2 Wire HD Video Intercom Release Note (2025-12-23)

2 Wire HD Video Intercom Release Note (2025-10-21)

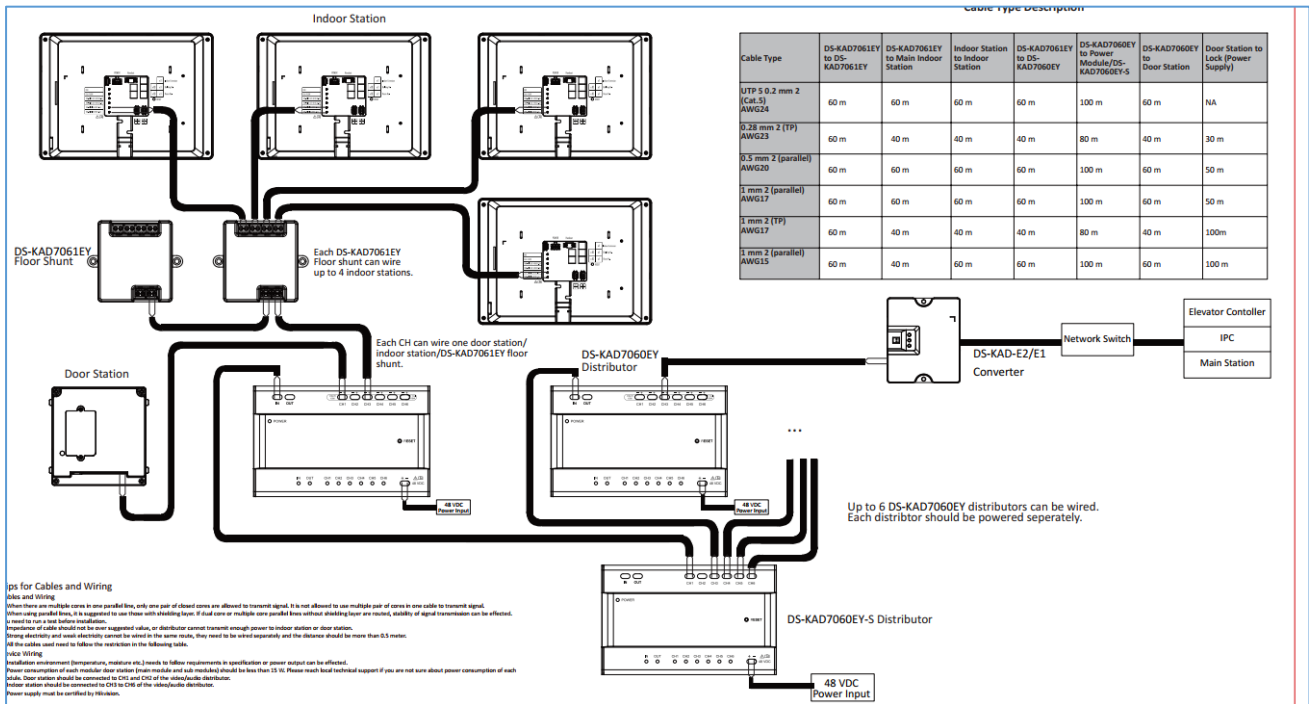
The 2 wire HD to IP converter DS-KAD-E2/E1 is released. we can call elevator, live view IP camera, call main station DS-KM9503 on 2 wire HD door station and indoor station

- support connecting to IP intercom main station
- support adding IPC to Indoor monitor.
- support 2 wire HD system work with lift controller.
- 1 Two-Wire Interface to connect ground distributor, 1 RJ45 port to connect to IP device , 3 indicators
- Support AP mode, power by 12V/DC or POE
- Topology

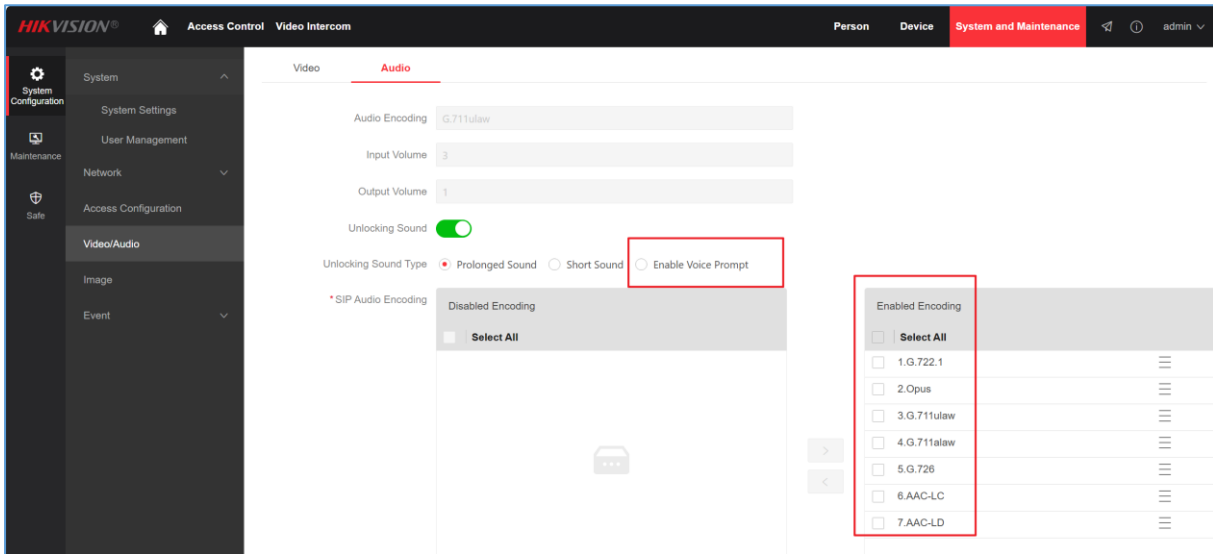
1. KD7003 support trade button (automatically unlock door after receive call) function.
For example, if you set same schedule as below pictures, the door will unlock automatically after receive the call from button1 between Monday to Friday 8:00-18:00

- 1) Each button (of main module and nametag DS-KD-KK or DS-KD-K12 module) can only be linked to one template only.
- 2) Only lock1 will be open automatically, lock2 doesn't support trade button function.

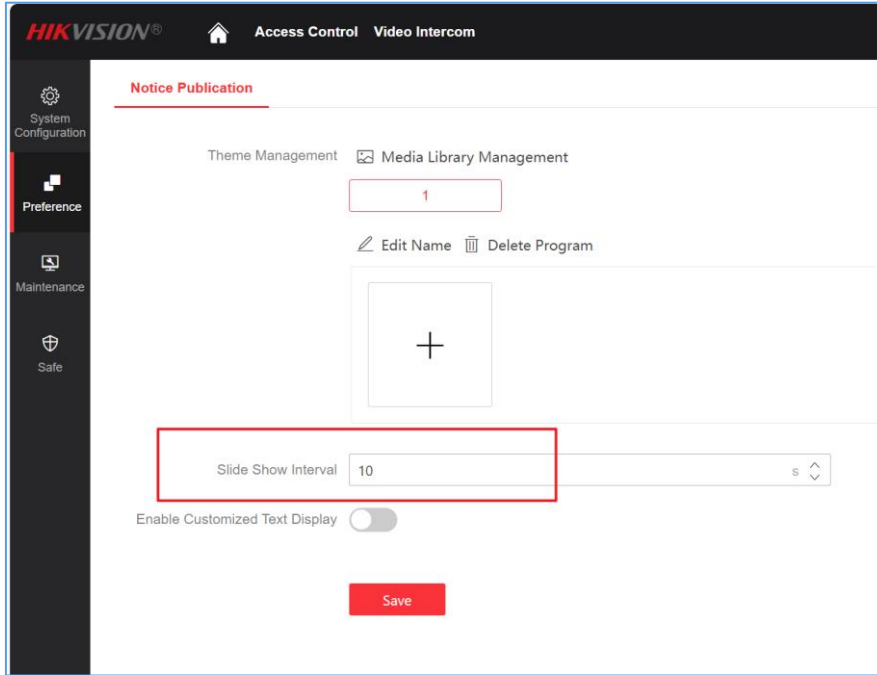
2. Change the rotary switch for lock control logic.

Note: 1. When it's set to 0-8, the unlock duration is fixed, when set to 9, you can set the open duration on the webpage.

2. When it's set to 0/1/2, only lock 1(DC pulse) is valid and you can see one lock icon on indoor station; when it's 3/4/5, only lock2(relay) is valid and you can see one lock icon on indoor station; when it's 6/7/8, lock1&lock2 are valid and two lock icons on indoor station.

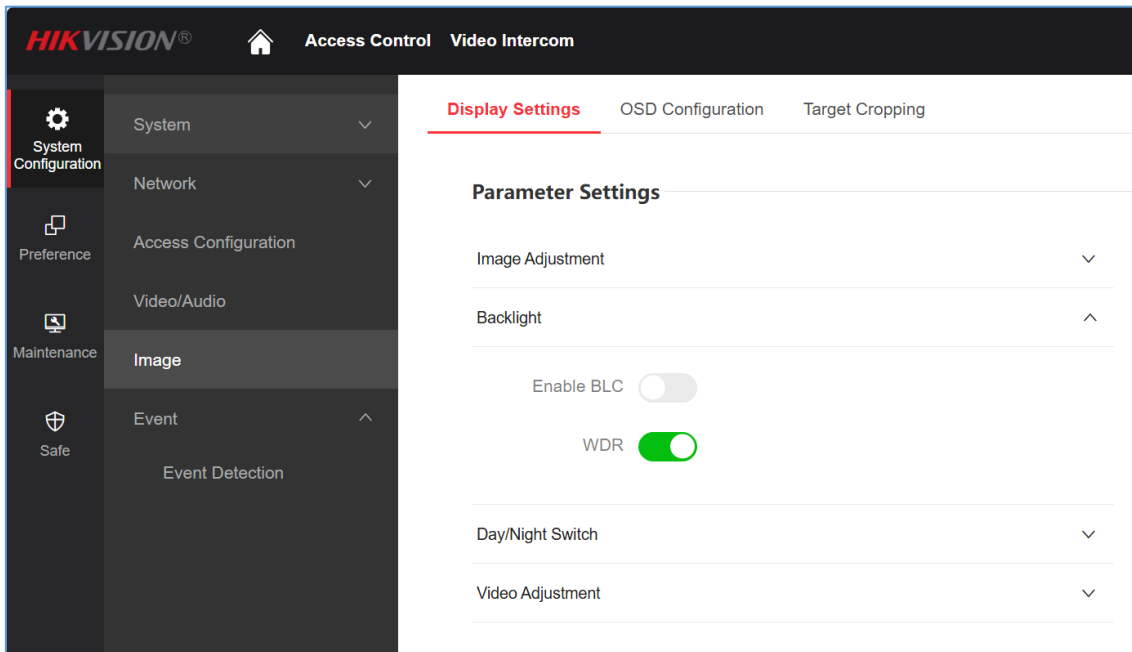
3. Change the default advertisement picture duration to 10s on touch display module

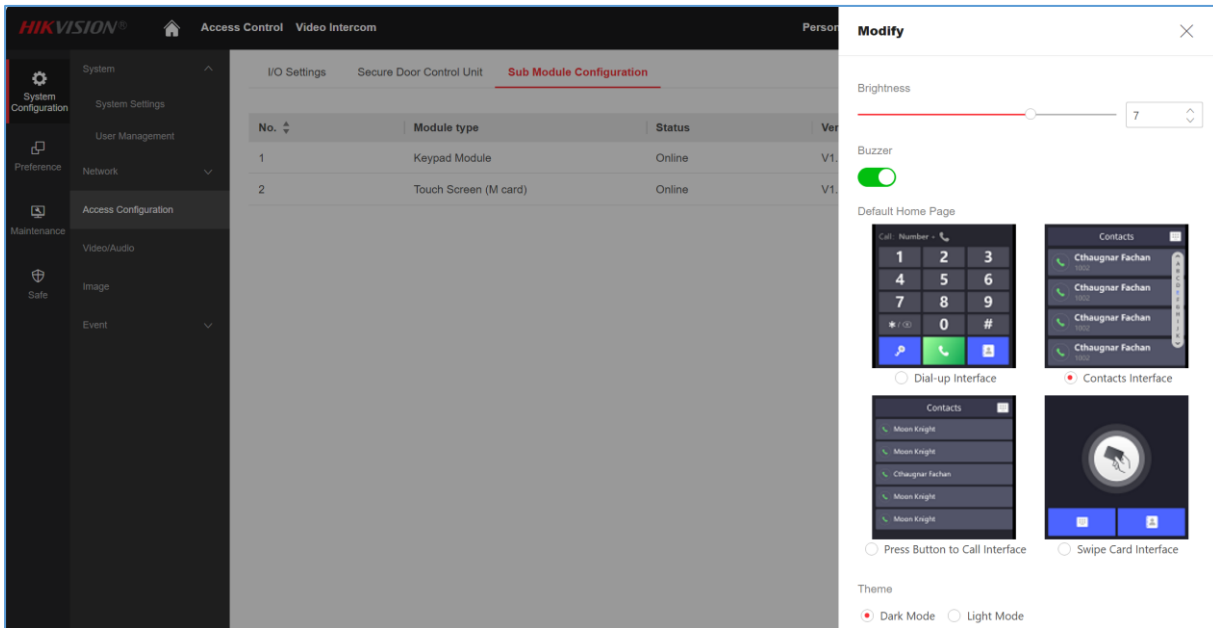
4. Change the motion detection logic, after trigger the motion, the touch display module will still play the advertisement picture for 5s before enter the default home page
5. Optimize the video quality, and enable WDR by default

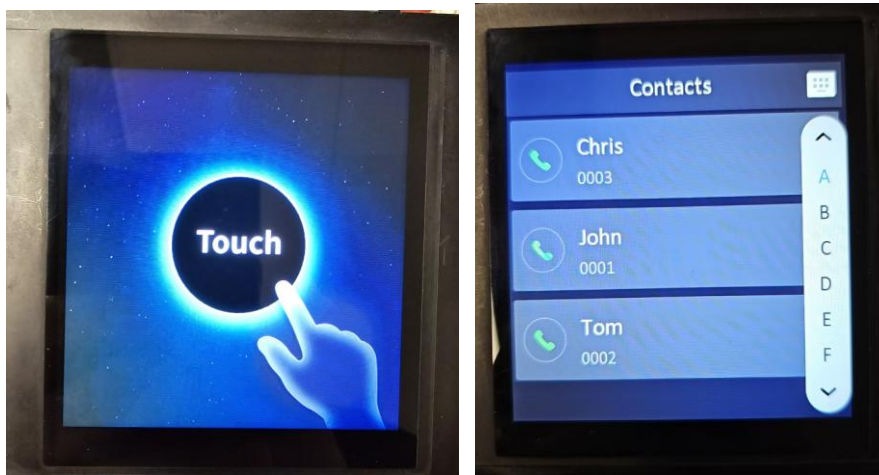
6. Optimize the screen light up logic. When calling from door station, the indoor extension screen will be light up before press the unlock button, maximum support 2 indoor stations screen light up at the same time (1 indoor station + 1 indoor extension)
7. Change the default home page of touch display module to contact list page.

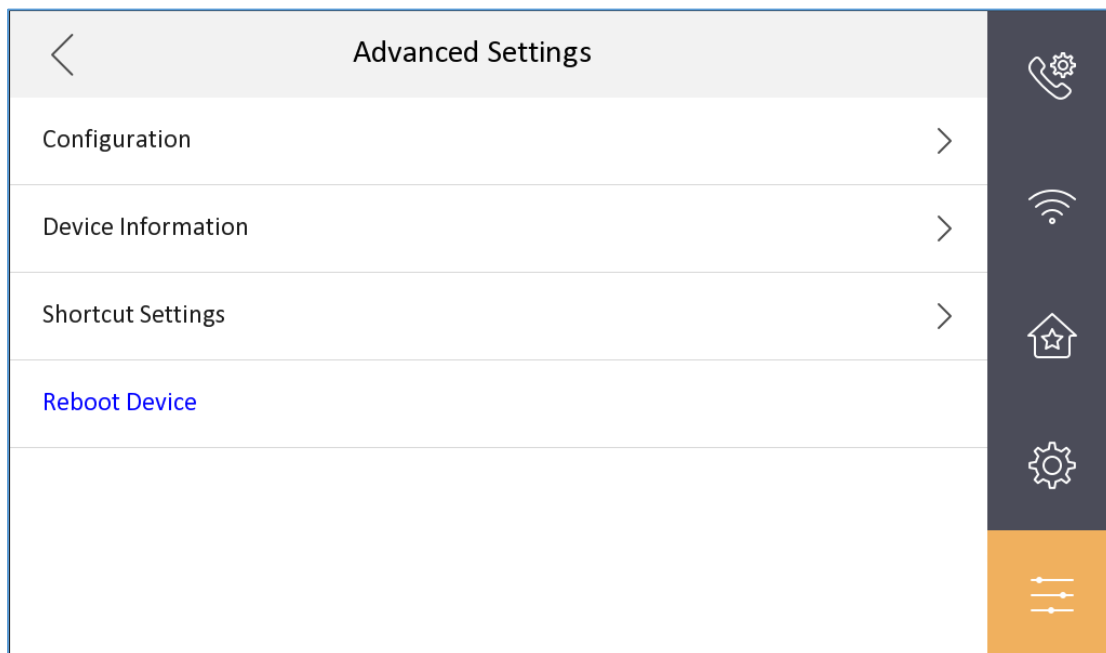
12. Optimize the 4.3 inch indoor station UI

DS-KD7000EY-ME2/Aluminum

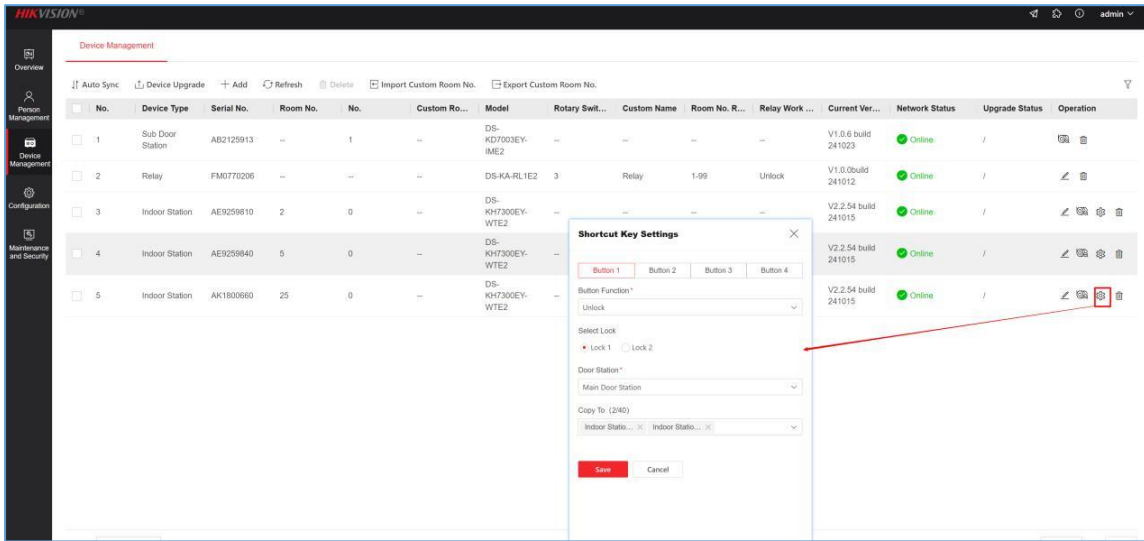
1. Release new door station

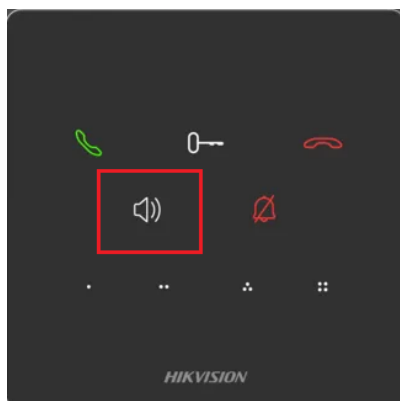
2. When the 4th DIP switch set to ON, the unlock button and 4 self-defined shortcut key will work only during the call or the indoor station is ringing.
If it's default OFF status, the unlock button and 4 keys will always take effect.
